**SILVER BOW CREEK/BUTTE AREA NPL SITE
BUTTE PRIORITY SOILS OPERABLE UNIT**

*Butte Reduction Works (BRW) Smelter Area Mine
Waste Remediation and Contaminated
Groundwater Hydraulic Control Site
Pre-Design Investigation (PDI) Evaluation Report*

Revision 0 May 2021

**RESPONSE TO AGENCY COMMENTS
FOR THE
BUTTE PRIORITY SOILS OPERABLE UNIT (BPSOU) BUTTE REDUCTION WORKS
(BRW) SMELTER AREA MINE WASTE REMEDIATION AND CONTAMINATED
GROUNDWATER HYDRAULIC CONTROL SITE
PRE-DESIGN INVESTIGATION (PDI) EVALUATION REPORT
DATED OCTOBER 6, 2020**

DISPLAYED AS: PROJECTION/ZONE: MSP DATUM: NAD 83 UNITS: INT'L FT SOURCE: PIONEER/CAD-EARTH	FIGURE 3 	BRW SMELTER AREA CONCEPTUAL REMEDIAL ACTION PLAN DATE: 5/11/2021

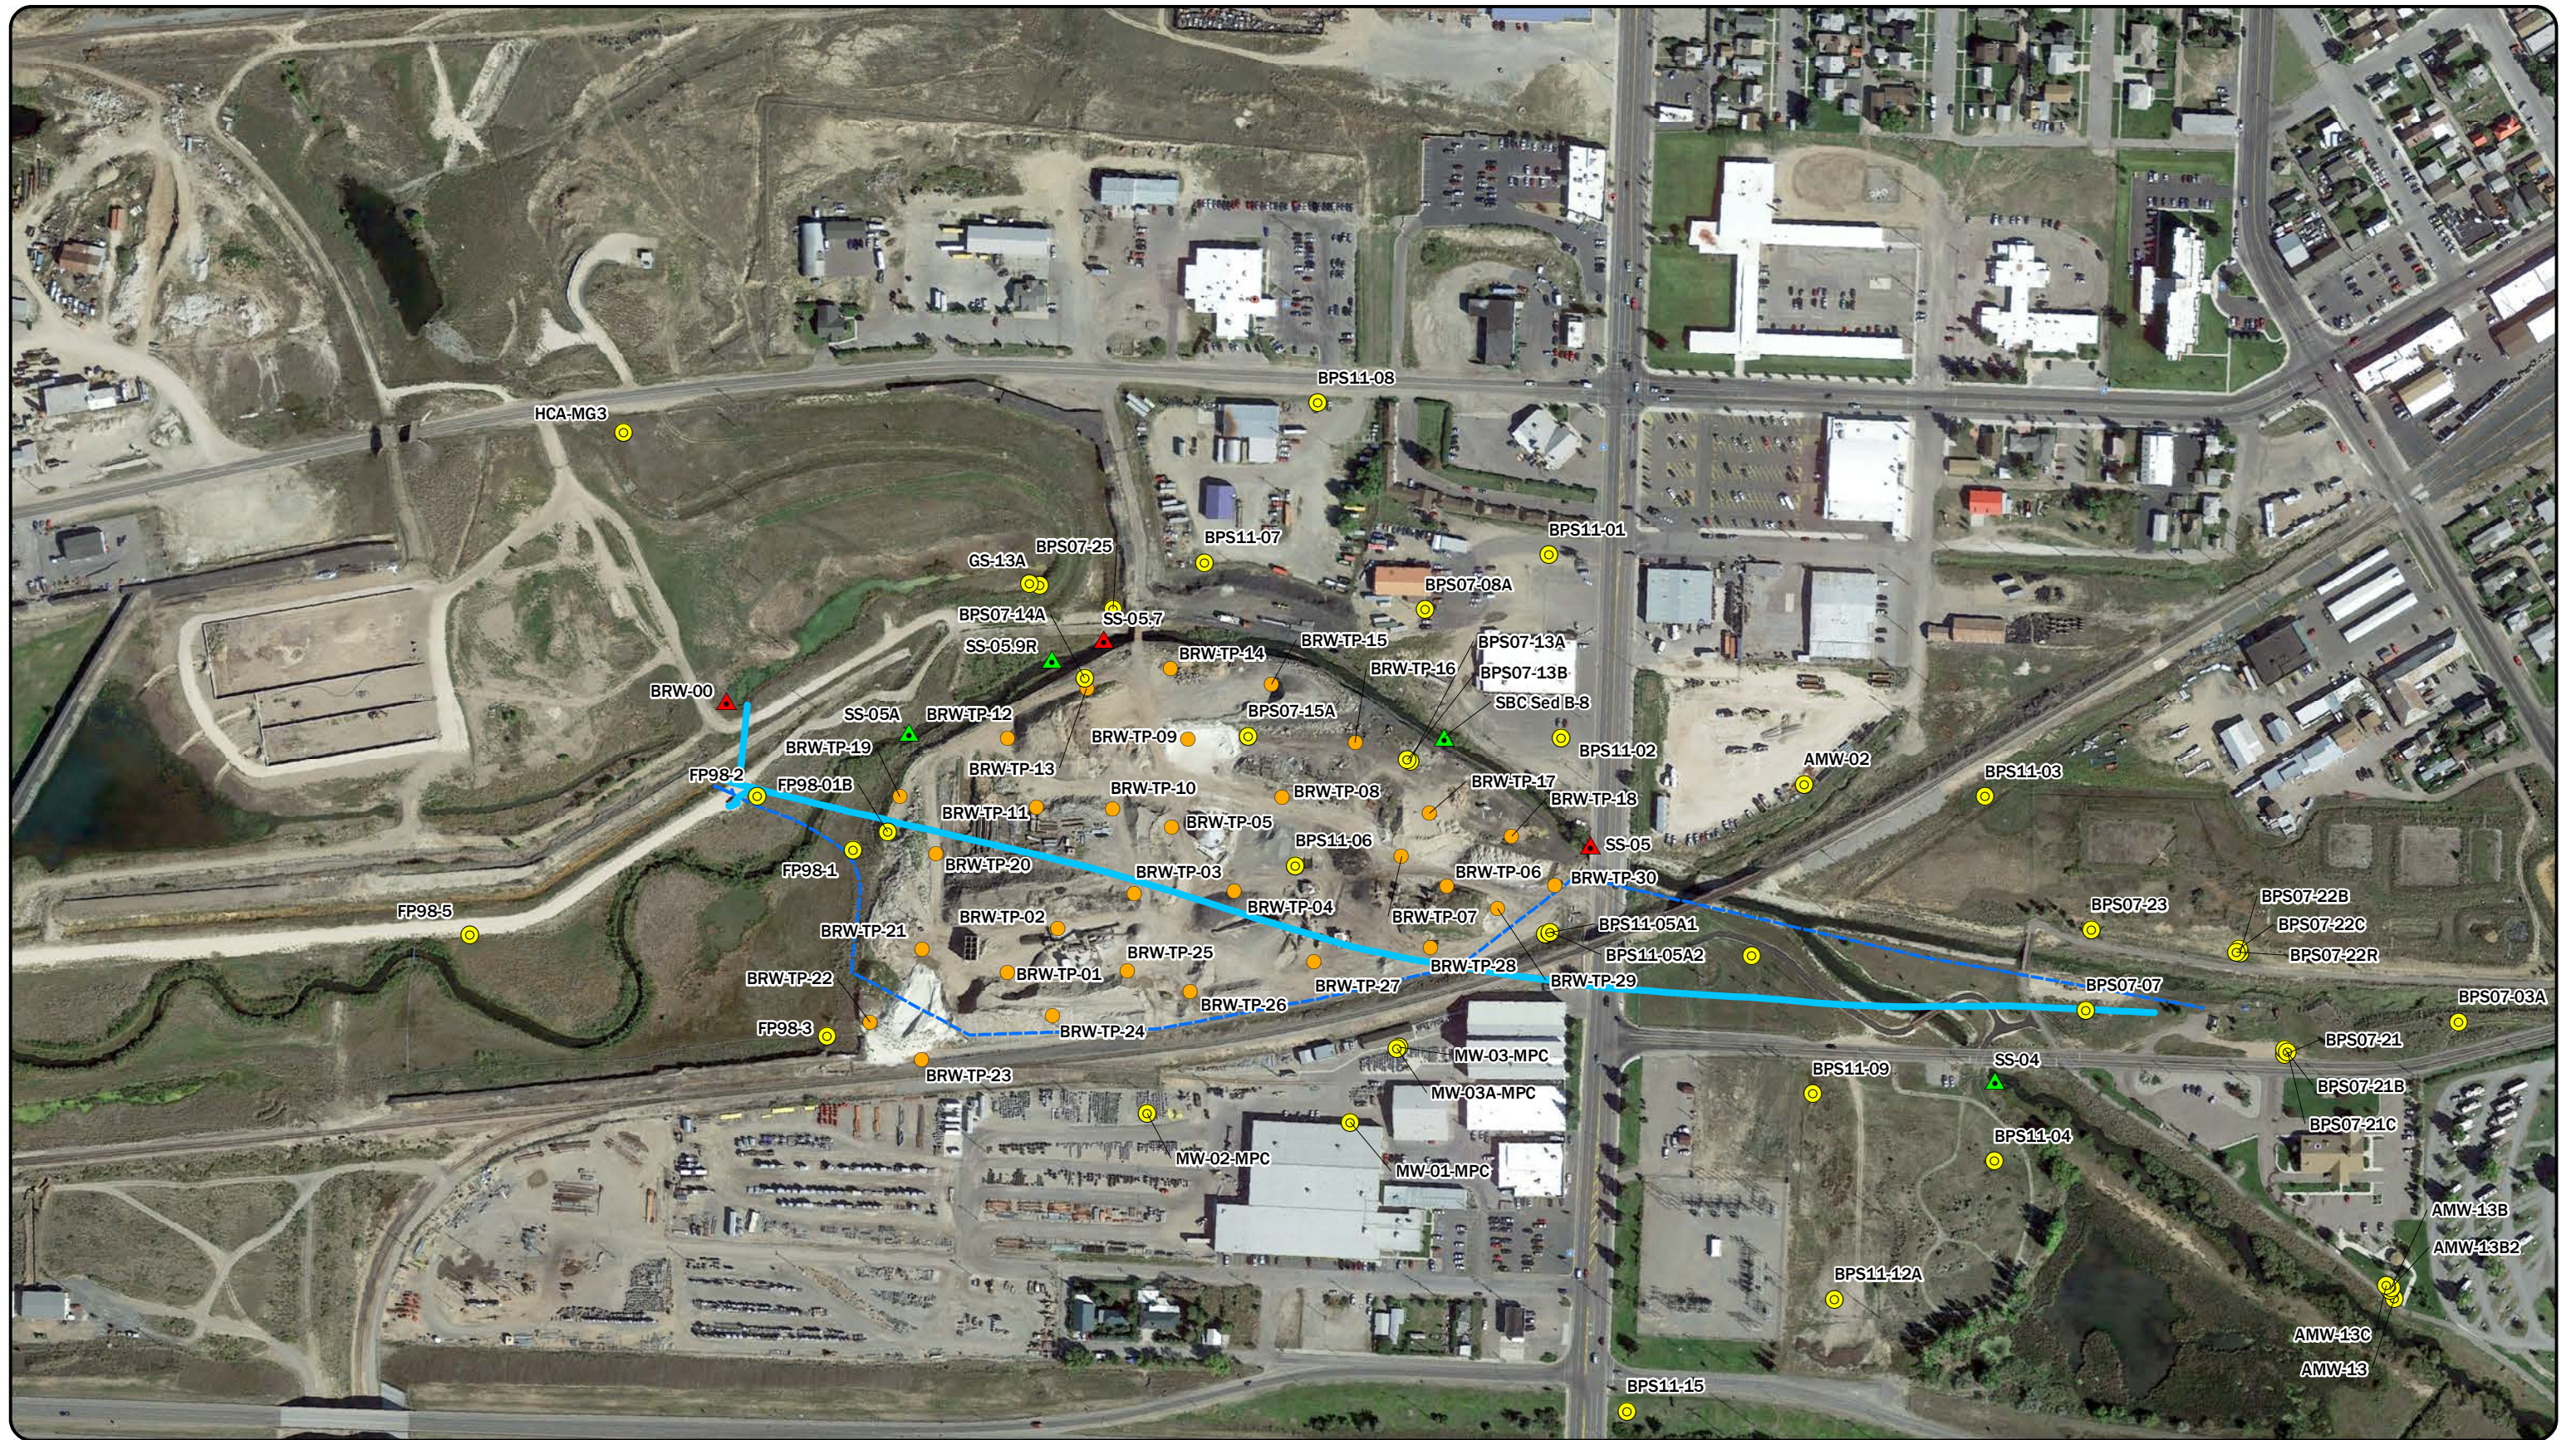
EPA Specific Comment 6: *Section 5.3 – The proposed preservation of the ore bins would require a significant change in the tailings, waste, and contaminated soil removal area depicted on Figure BRW-1 of the Future Remedial Elements (FRE) statement of work (SOW). This change needs further discussion to evaluate potential impacts to the efficacy of the remedy.*

Atlantic Richfield Company Response: Figure BRW-1 of the Future Remedial Elements Statement of Work (FRESOW) is a conceptual illustration. The FRESOW requires an excavation that maintains an average width of 275 feet (north to south) beginning at the toe of the railroad and extending north into the Site. A cultural resource inventory is currently in progress, and waste removal and regrading design will accommodate preserving historical features (e.g., the manganese ore bins and slag walls) to the extent possible. Additional text has been added to Section 5.3 of the report to clarify the intended steps of the ongoing evaluation, the results of which will be incorporated into this BRW PDI ER once Site investigation activities are completed.

FIGURE 14

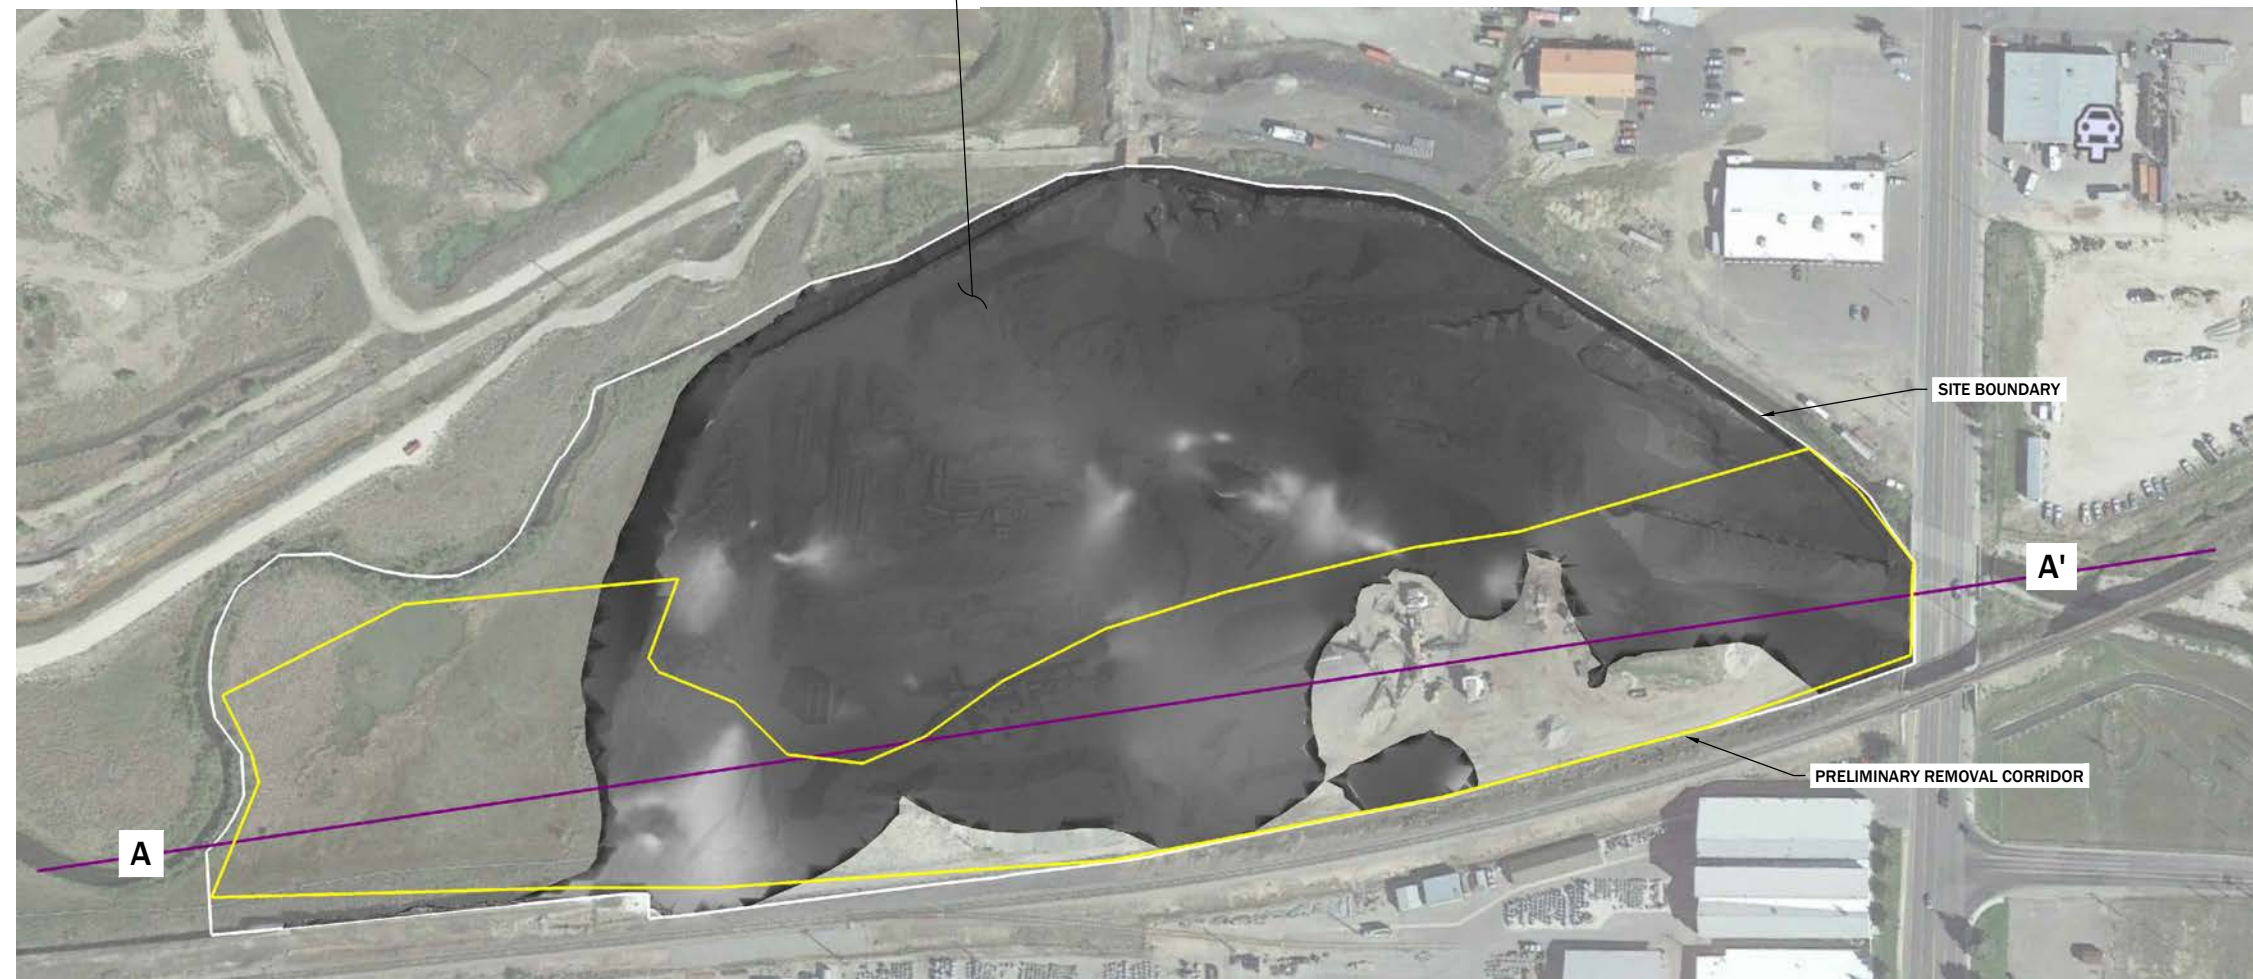
EPA Specific Comment 3: *Section 2.4 – First Paragraph: Text references Figure 15 for known utilities; the correct reference is Figure 16.*
